Kenmore Town Green
Addendum No. 1
Sept 4, 2015

B. Drawing Revisions: The attached revisions shall be made part of the Bid Set Drawings, dated August 19th, 2015, for the above referenced project.

KENMORE TOWN GREEN

PROJECT NO.: 114410 DRAWING NO.:
SCALE: AS NOTED **C5.00**
DATE: 6/08/15 SHEET 10 OF 11

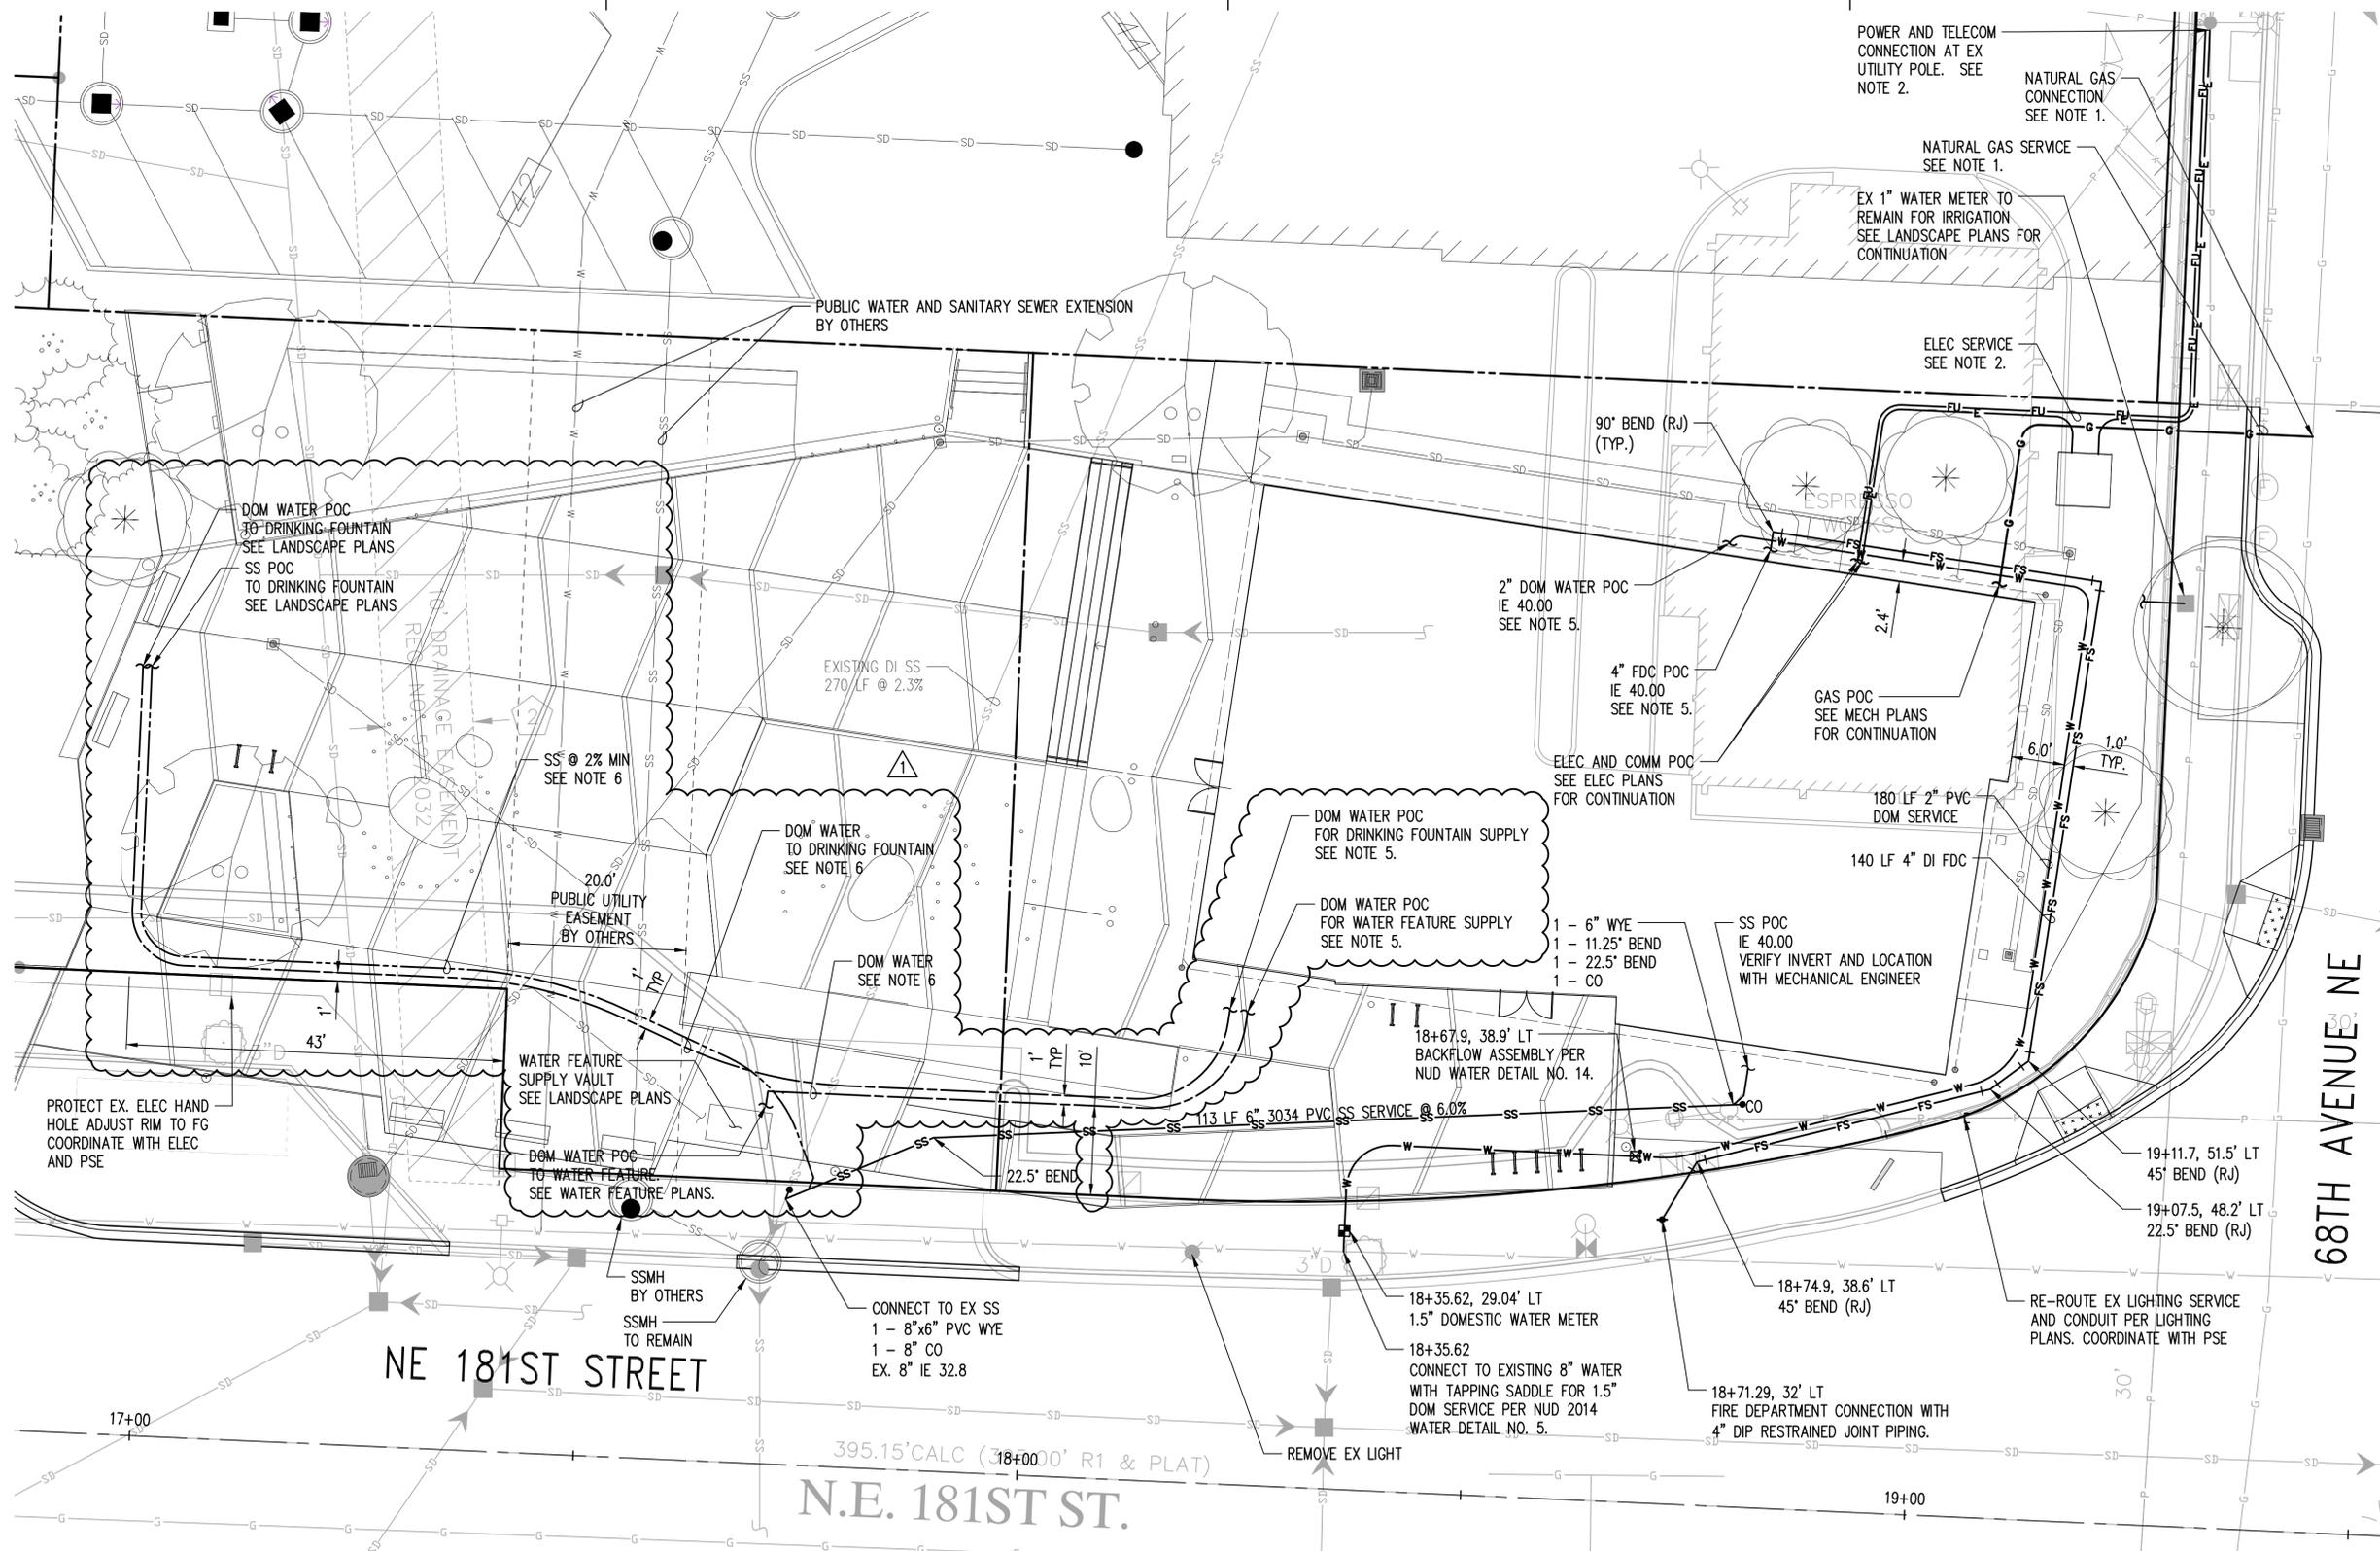
Project Manual Revisions		
Item	Spec Section	Description of Change
Addendum 01 – 1	Bidding Requirements Proposal and Documents	Section 2 – Instructions to Bidders: Addition of a Substitution Request Form has been issued: CSI Form 01 5C.
Addendum 01 – 2	Bidding Requirements Proposal and Documents	Section 2 –Substitution Requests submission deadline is extended to Sept 9 at noon.
Addendum 01 – 3	33 10 00 Water Distribution Piping	See revisions.
Addendum 01 – 4	07 41 13 Roof Material	See revisions.
Item	Document	Description of Change
Addendum 01 – 5	A2.21	Change callout of saw-cut joint filler from 'epoxy' to 'polyurea'. Drawing not included at this time.
Addendum 01 – 6	C3.01	Revision made of connection to existing CB.
Addendum 01 – 7	C4.00	Revision to limits of overlay.
Addendum 01 – 8	C5.00	Revisions to callouts for water feature vault and drinking fountain.

PROJECT NO: **114410** DRAWING NO.:
SCALE: **C6.00**
AS NOTED SHEET **11** OF **11**
DATE: **6/08/15**

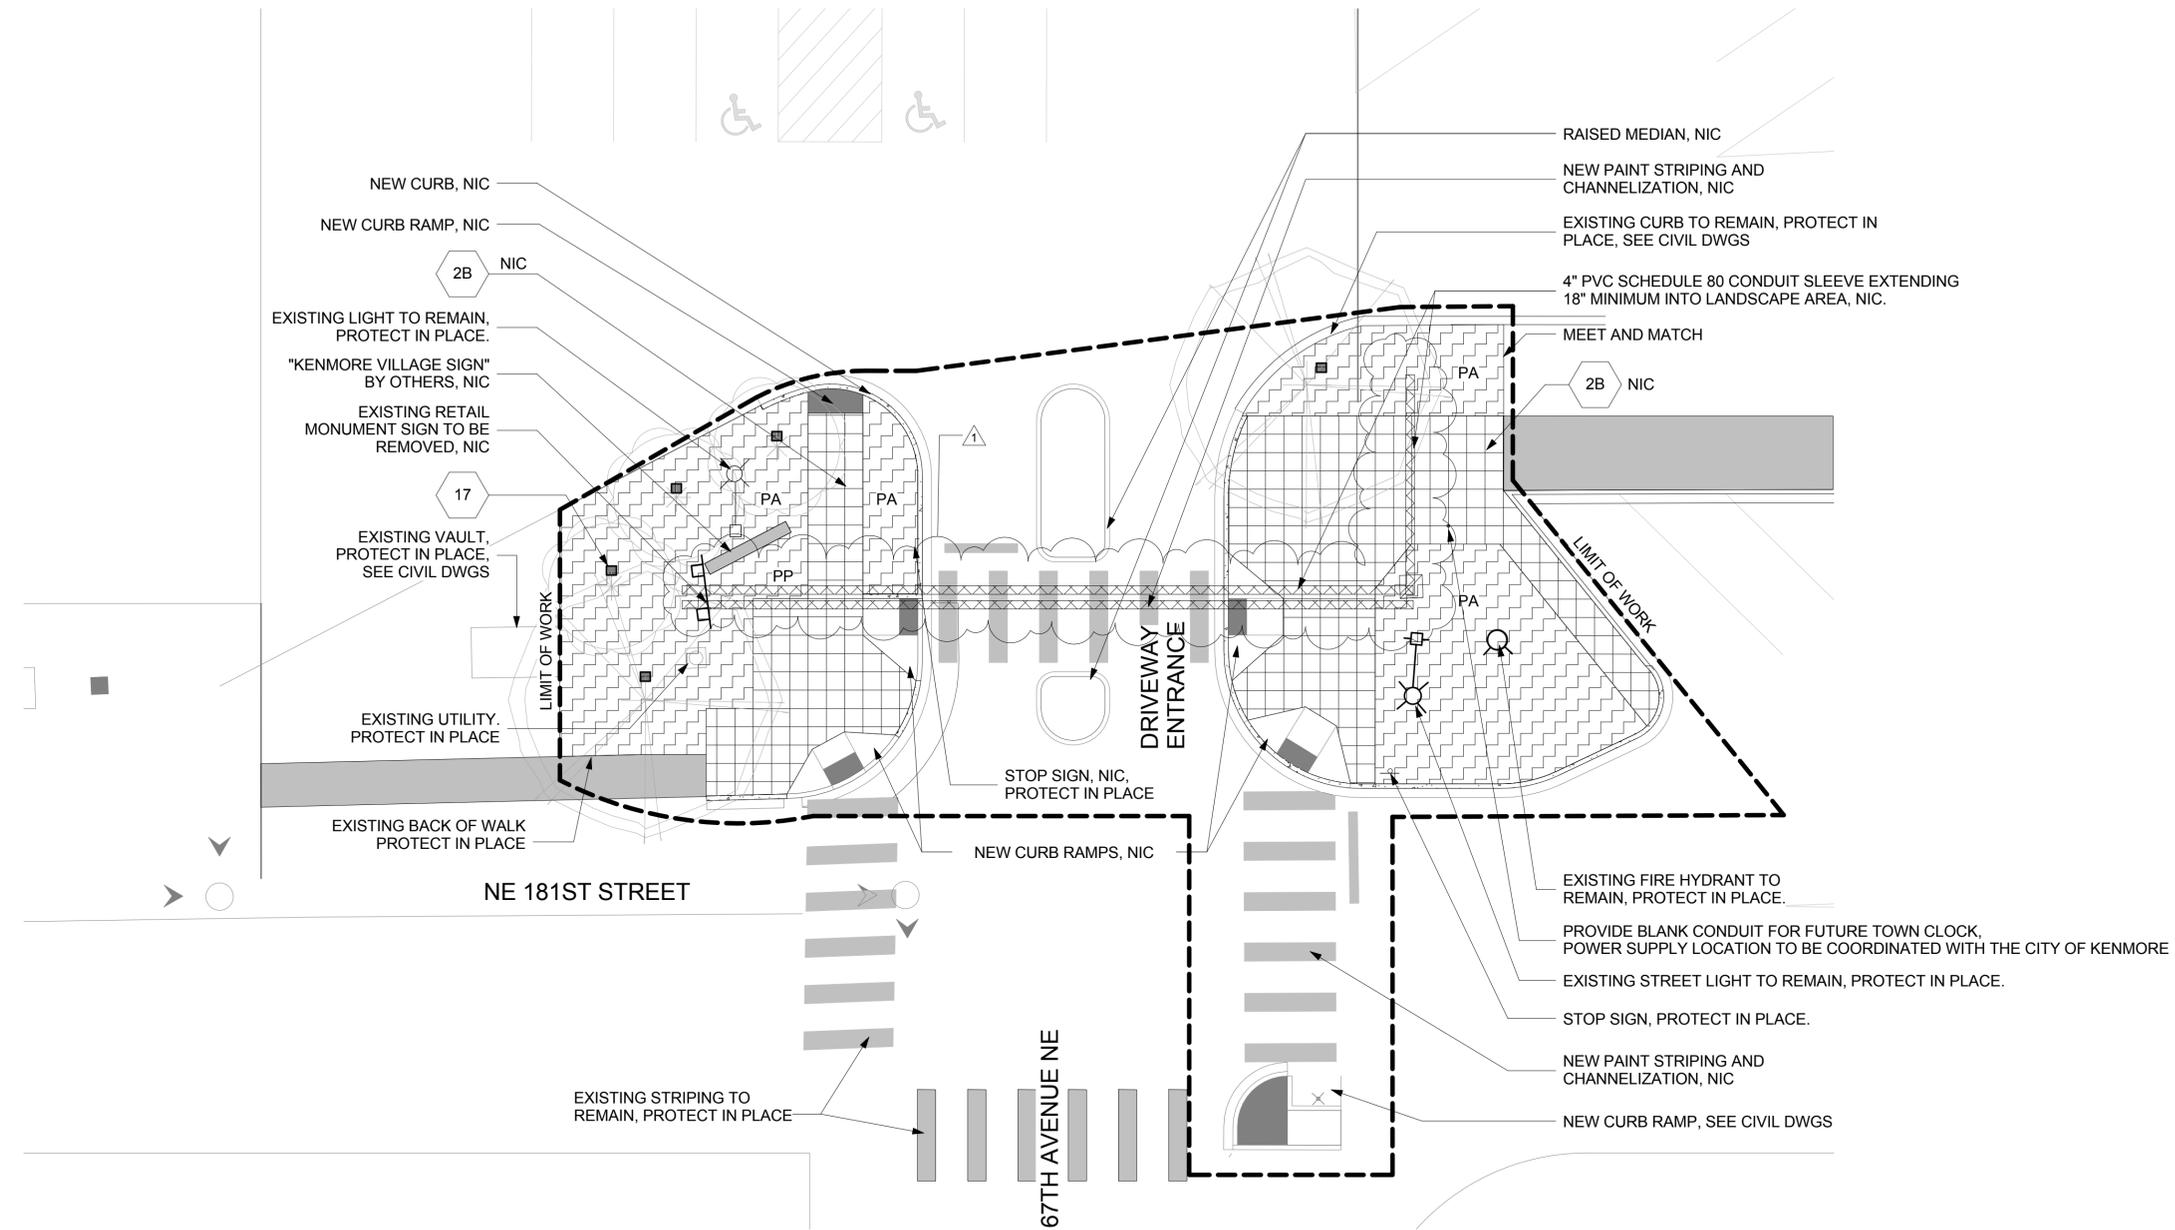
Project Manual Revisions		
Item	Spec Section	Description of Change
Addendum 01 – 9	C6.00	Revisions to the ADA Ramp located in the southeast corner of the intersection at 67 th & 181 st . Revisions of north raised median.
Addendum 01 – 10	L1.02	Adjustment to the Legend and General Notes have been made. Inclusion of conduit for reference purposes only as they are not in contract but will be installed prior to this projects construction commencing.
Addendum 01 – 11	E0.10	Additional notation for power supply of GFCI's and irrigation controller.

IN CONTRACT:
LANDSCAPE PLANTINGS, SOIL, IRRIGATION, ELEC GFCIs
AND RAMP AT SOUTHEAST CORNER OF INTERSECTION.
SEE LANDSCAPE PLANS.

SHEET TITLE:
**SITE PLAN -
ELECTRICAL**

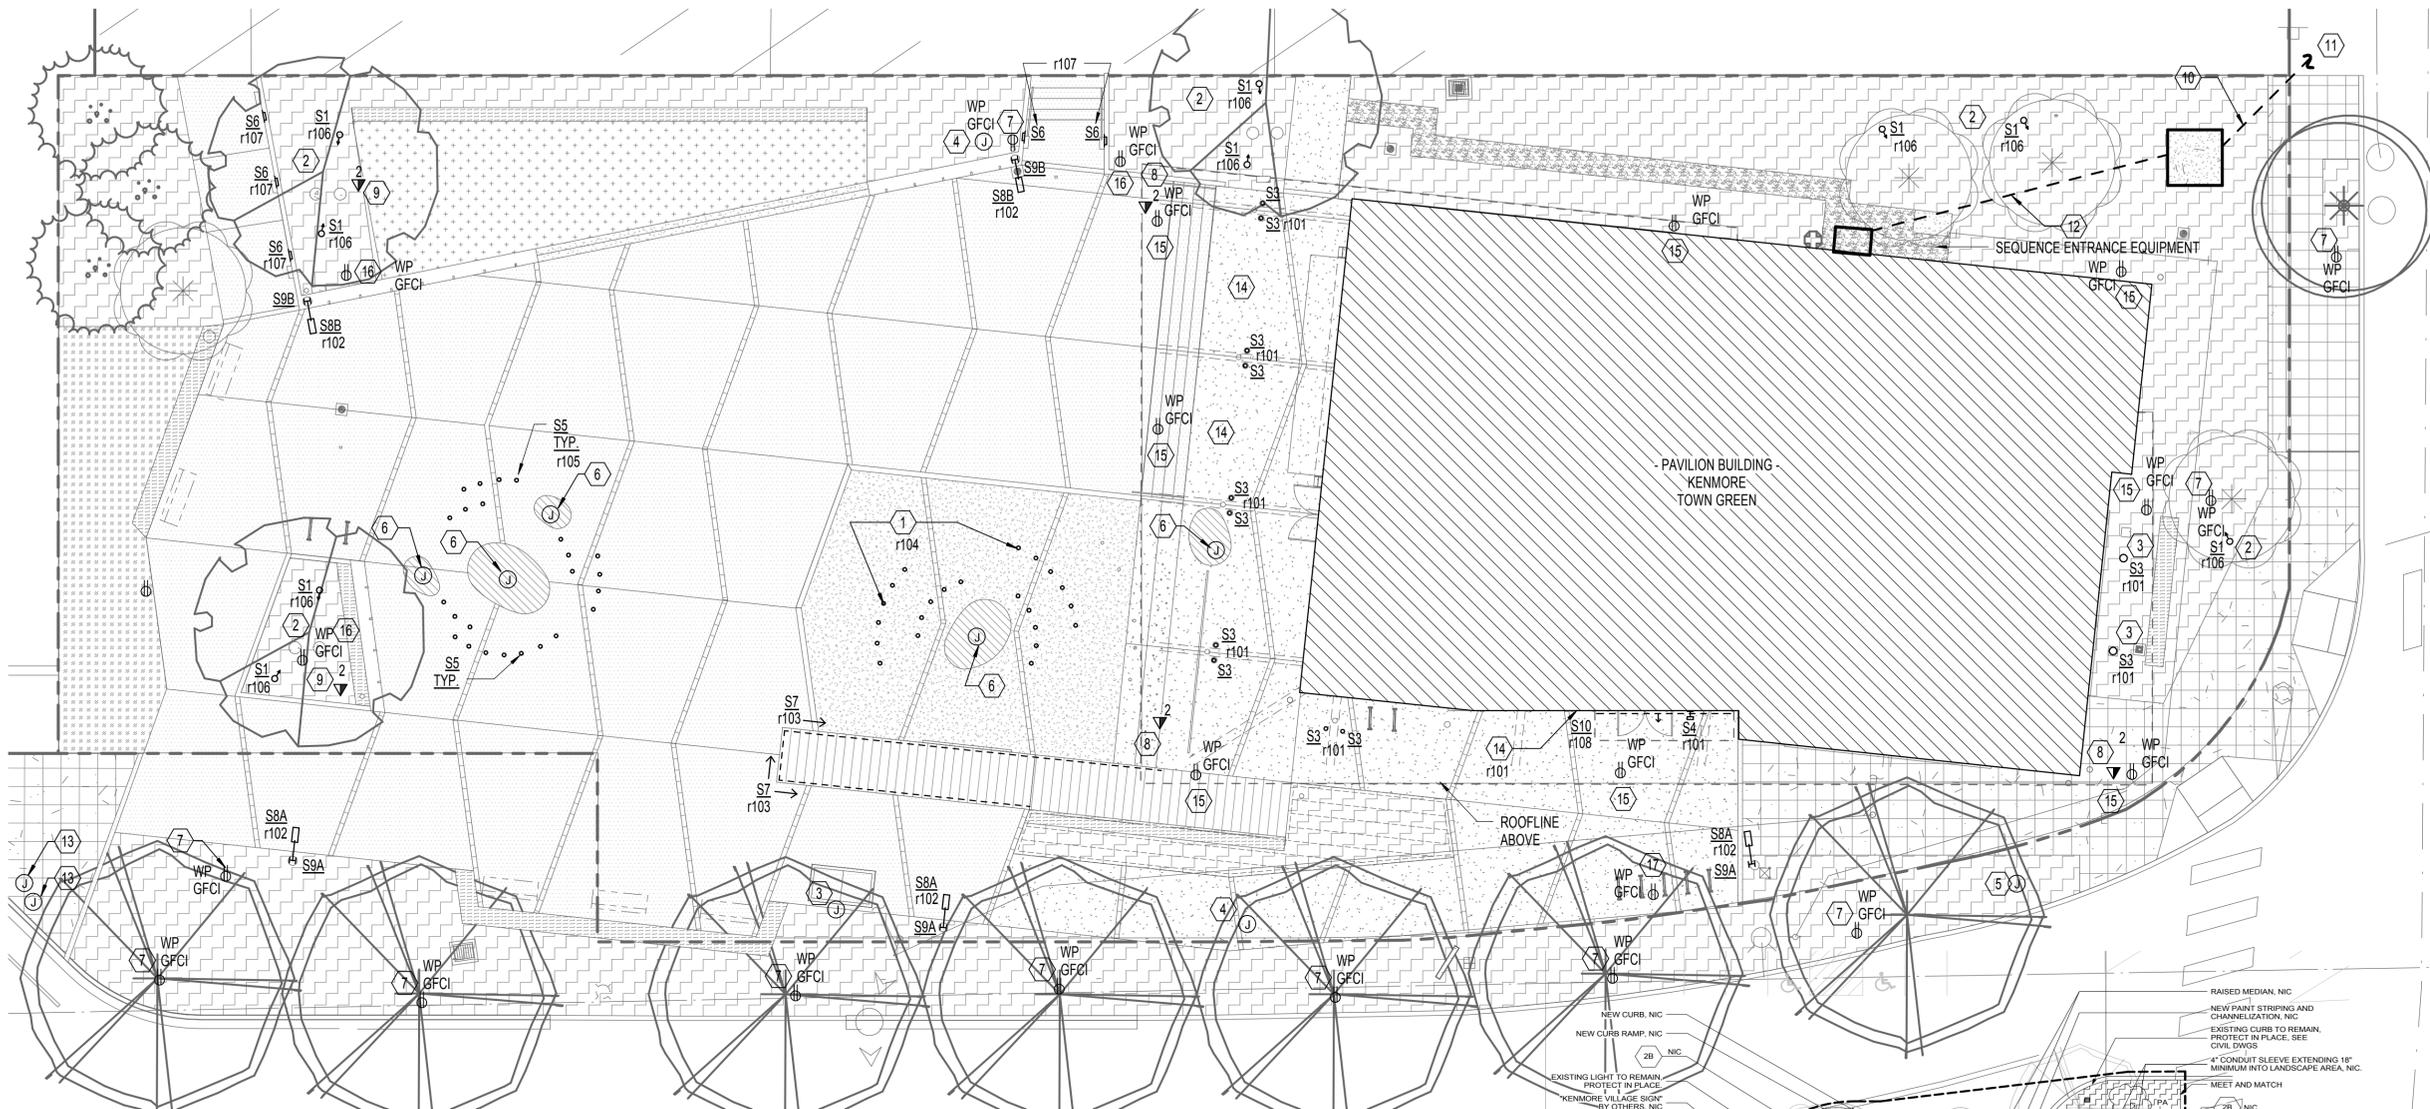
- 1. REFERENCE LANDSCAPE DRAWINGS L1.02 AND L4.02 FOR MORE INFORMATION. SNAPSHOT ABOVE INDICATES AREA OF WORK.
- 2. PROVIDE (1) GFCI PEDESTAL STYLE RECEPTACLE WITH METALLIC WHILE-IN-USE COVER AT (5) TREE LOCATIONS. INTERCEPT AND EXTEND EXISTING 120V CIRCUIT AT SERVICE PEDESTAL LOCATED AT EXISTING RETAIL SIGNAGE.
- 3. INTERCEPT AND EXTEND EXISTING 120V CIRCUIT AT SERVICE PEDESTAL NOTED ABOVE TO IRRIGATION CONTROLLER LOCATED IN LANDSCAPE AREA ACROSS 6TH.
- 4. PROVIDE (1) 1" CONDUIT BETWEEN LANDSCAPE AREAS FOR FUTURE CLOCK.
- 5. PROVIDE SINGLE PHASE KWH METER IN NEMA 4X, LOCKING ENCLOSURE FOR MONITORING POWER USAGE OF 120V CIRCUIT NOTED ABOVE. EMON DMON CLASS 1000 OR EQUAL. MOUNT AT EXISTING SERVICE PEDESTAL.
- 6. CITY OF KENMORE TO COORDINATE PHASING OF ELECTRICAL INSTALLATION WITH OWNER OF EXISTING POWER THAT WILL BE EXTENDED.
